room2 Homotel: Manchester Piccadilly

Design and Access Statement Addendum (Updated) – July 2024

Document Title	HMP-BA-XX-XX-TRP-A-0004 - Design and Access Statement Addendum (Updated)
Company	Bennetts Associates
Revision	P04
Date	9 th July 2024
Details	Design And Access Statement Addendum updated to address Case Officer comments issued on 13 th June 2024.
Document Number	HMP-BA-XX-XX-TRP-A-0004
Address	Bennetts Associates 38-42 Mosley Street Manchester M2 3AZ

Extracts from new Chatham Street bay study providing further details of the louvre designs

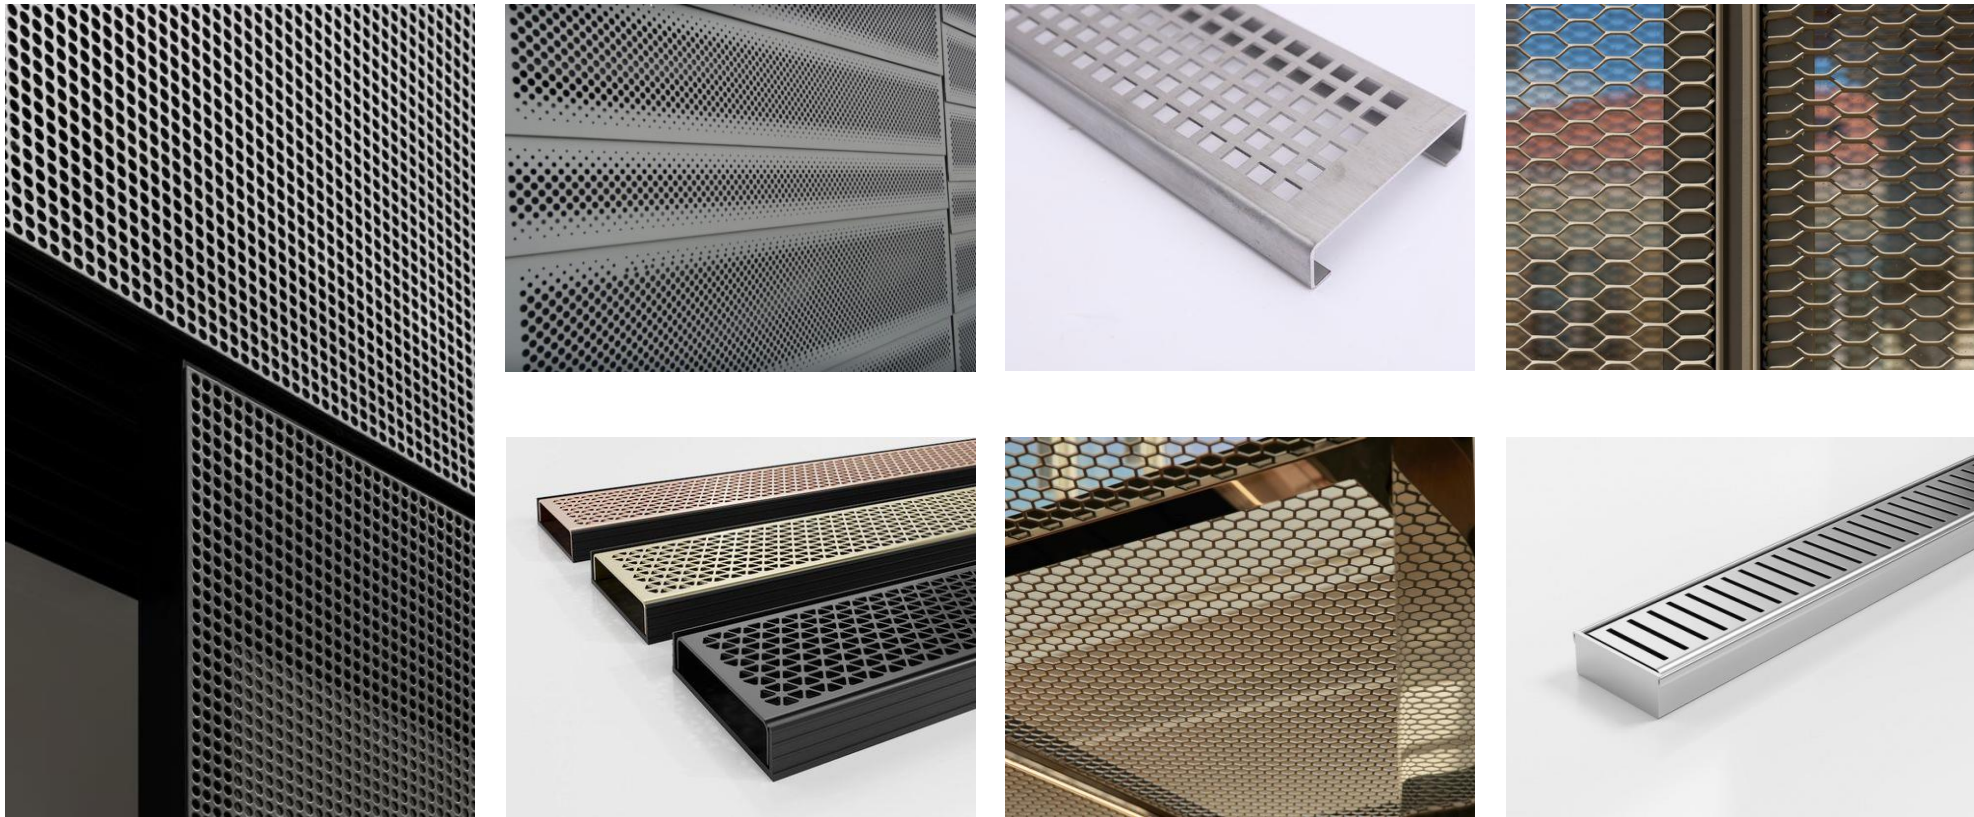
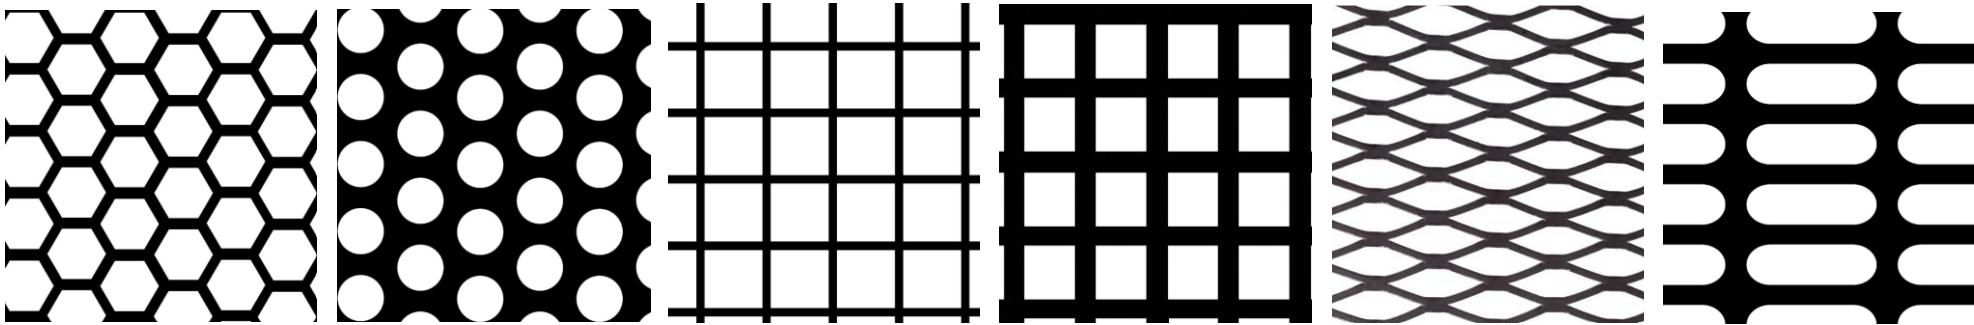
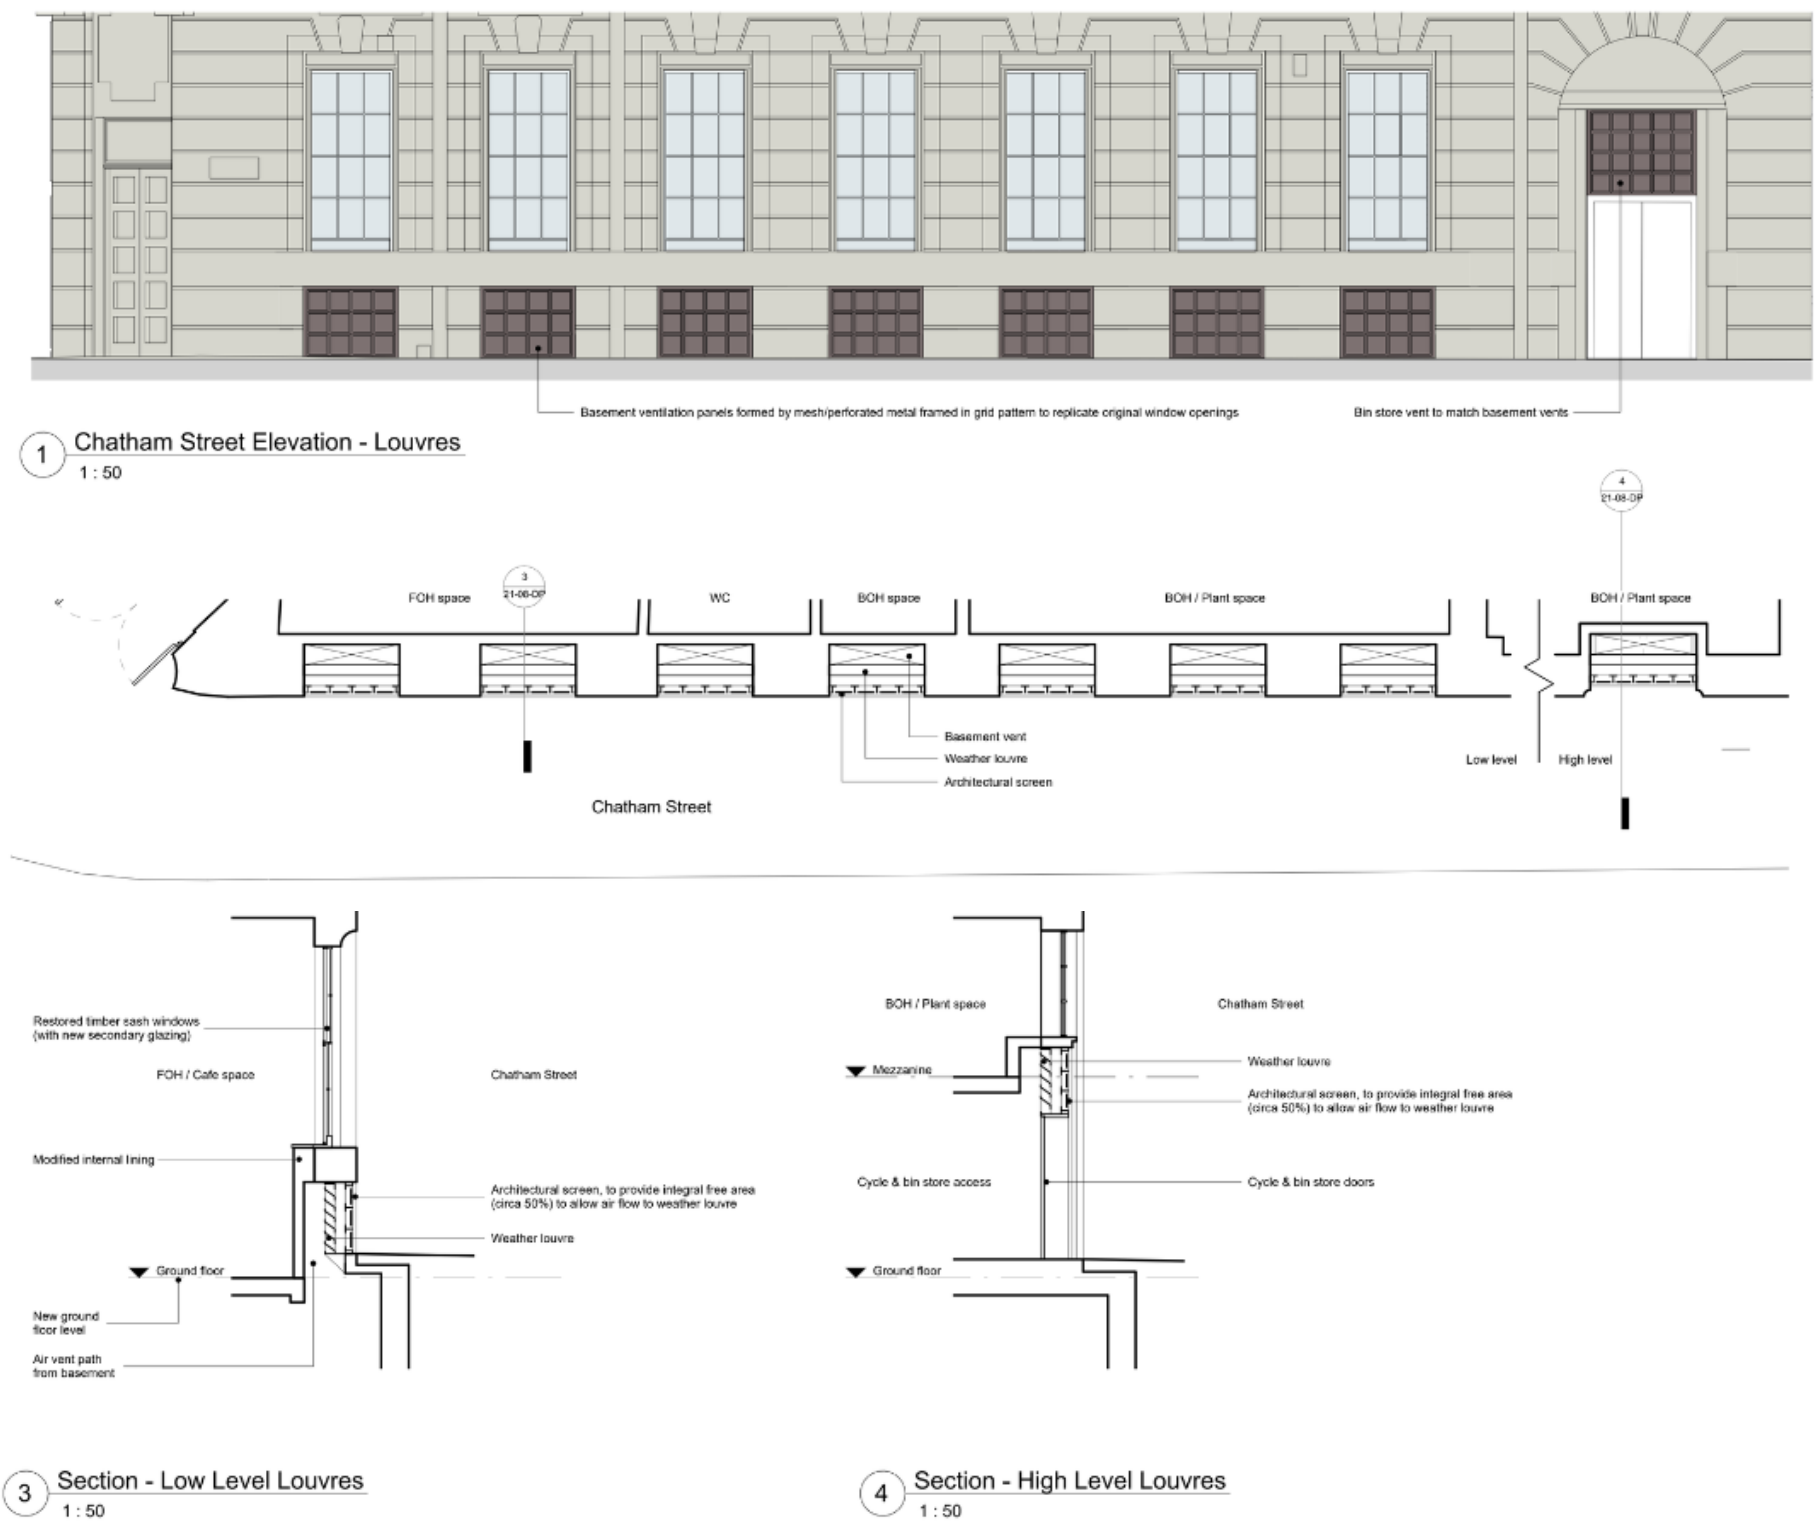
Louvres are of a functional design and will need finessing and this needs to be resolved at this stage. The louvre above the door note 6 is particularly poor and needs attention. Detailed design work and method statements need to be provided of the louvres. Detailed design of doorway 6 also required and how the alterations will be carried out. Method statement also required for their alteration.

We have investigated options to introduce a higher quality design solution for the areas of louvre on Chatham Street.

We propose a similar approach above the new doors with the gridded pattern modified to reference the multi pane sash windows located adjacent. To illustrate these proposals in greater detail we have added a new drawing (HMP-BA-21-08-DP-A-0) to our planning set, an extract of this is included on the next page.

Extracts from new Gore Street bay study providing further details of the vertical slatted screen.

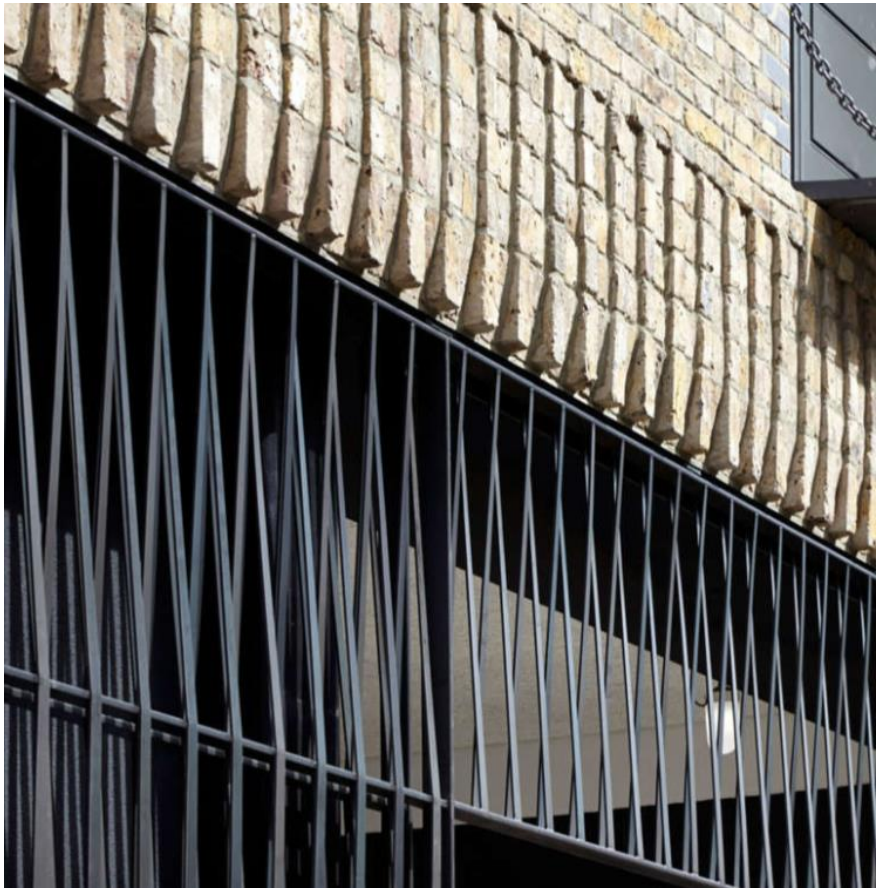
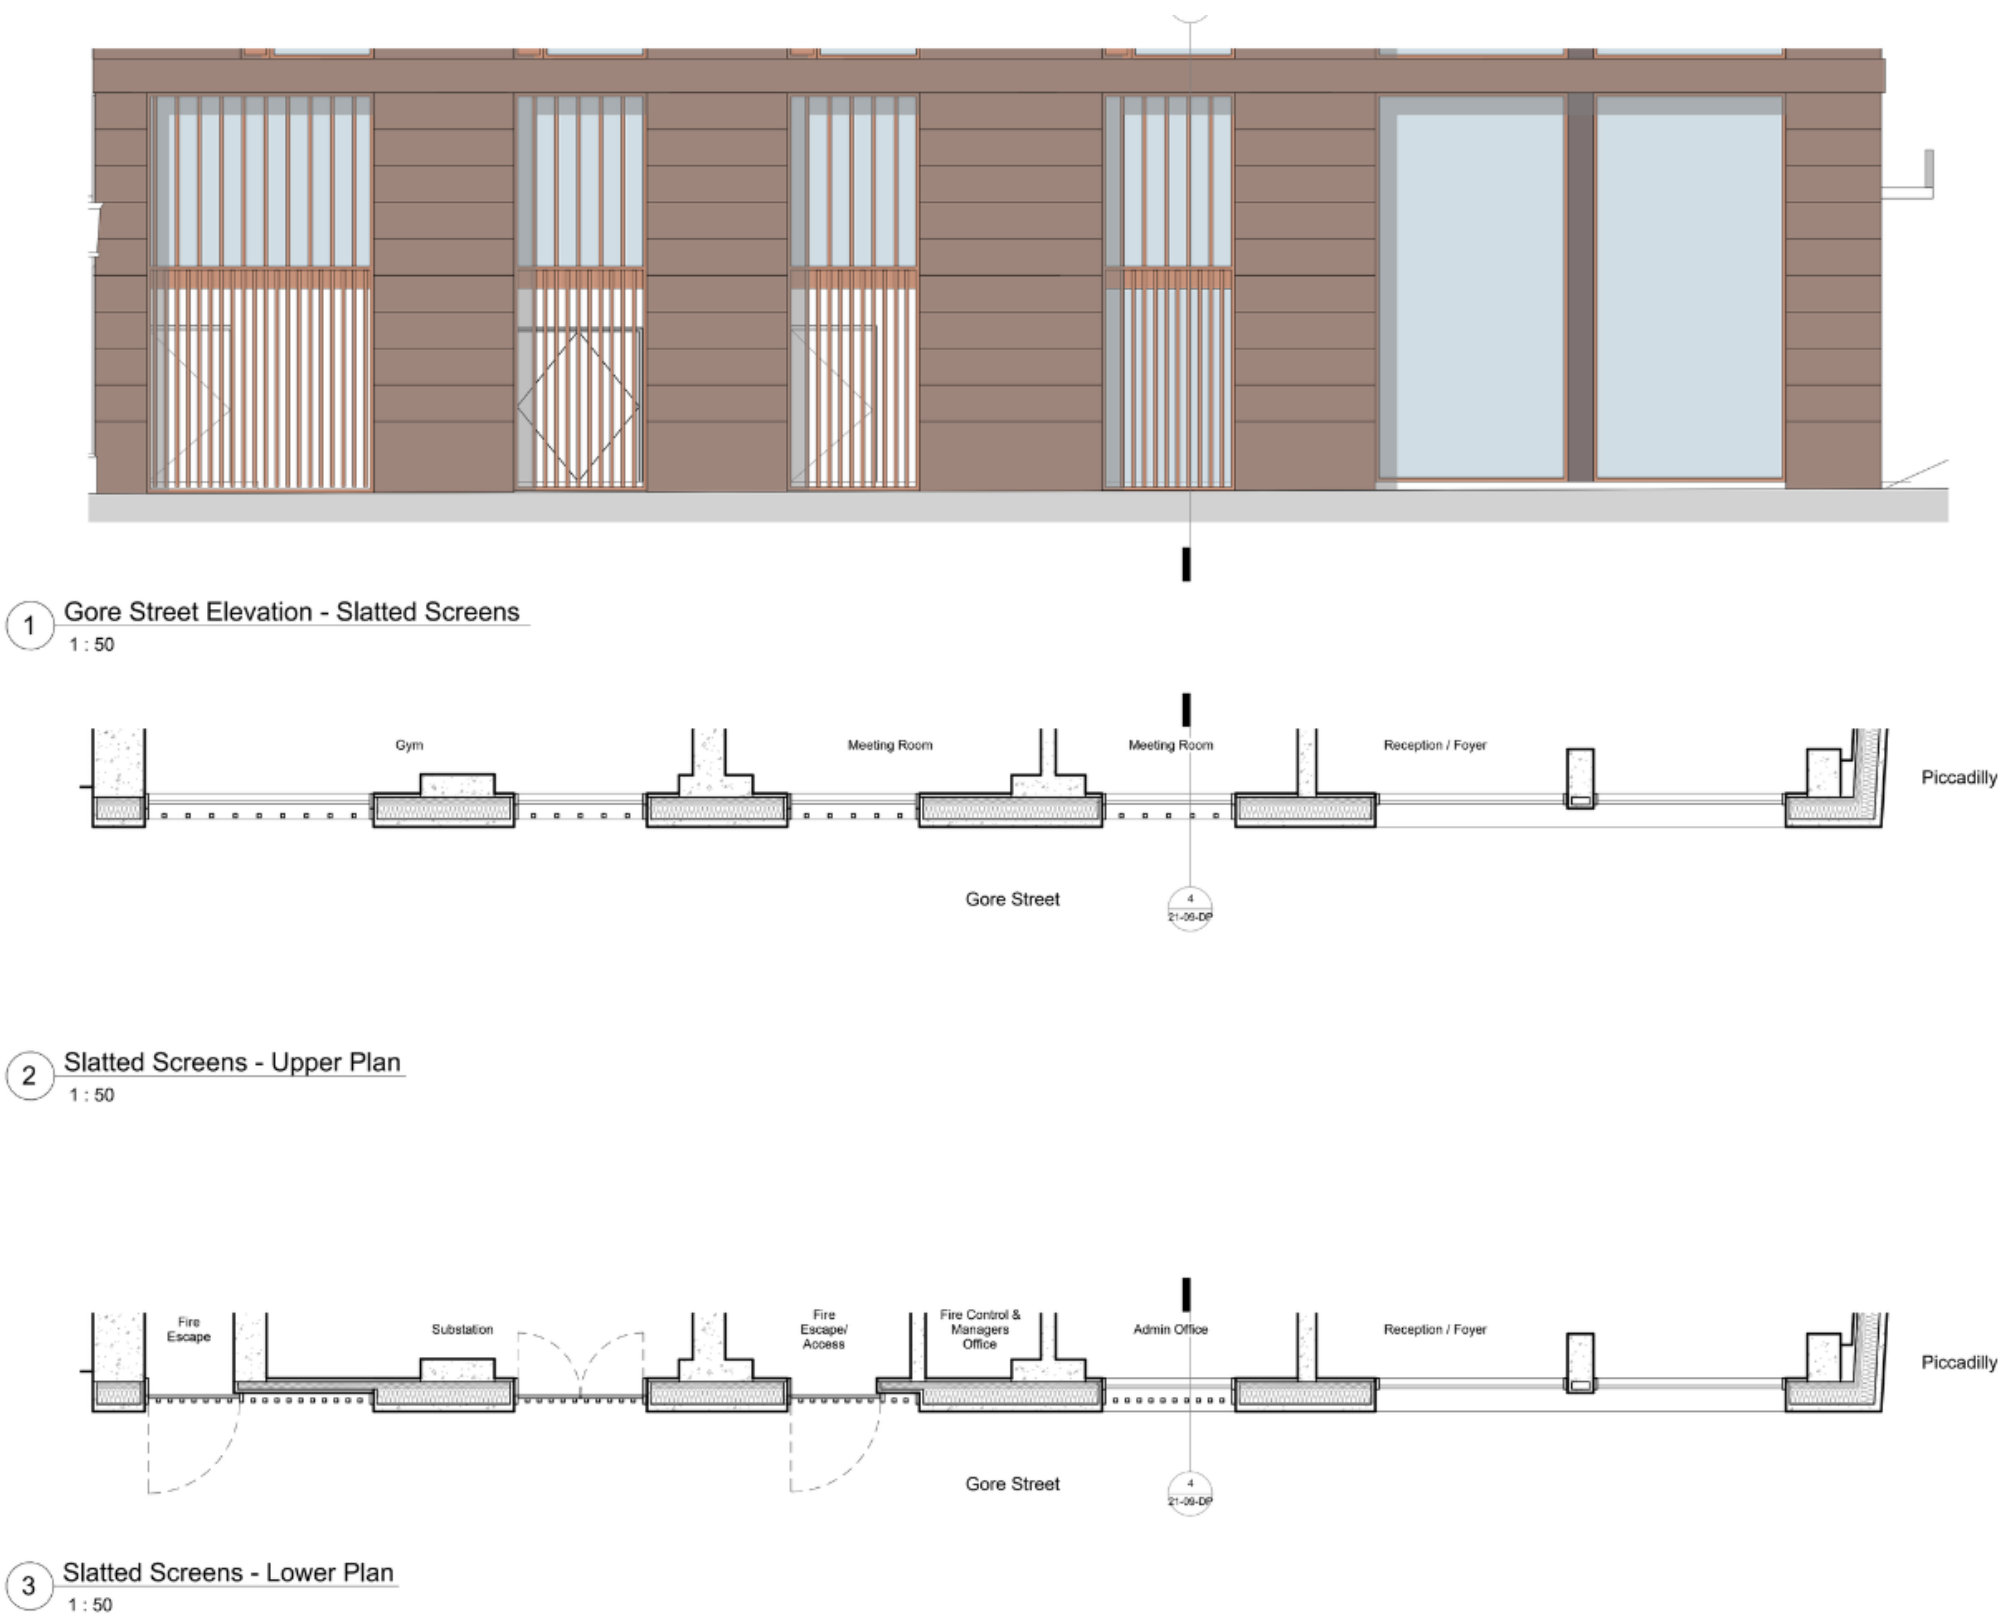
Original MCC comment:
Vertical slatted screen to Gore Street will need detailing.

Work in progress drawings of the vertical slatted screen to Gore Street were referred to in the meeting and draft images used to explain the concept of the proposed approach.

Following discussion, these principles were agreed. To illustrate these proposals in greater detail we have added a new drawing (HMP-BA-21-09-DP-A-0) to our planning set, an extract of this is included on the next page
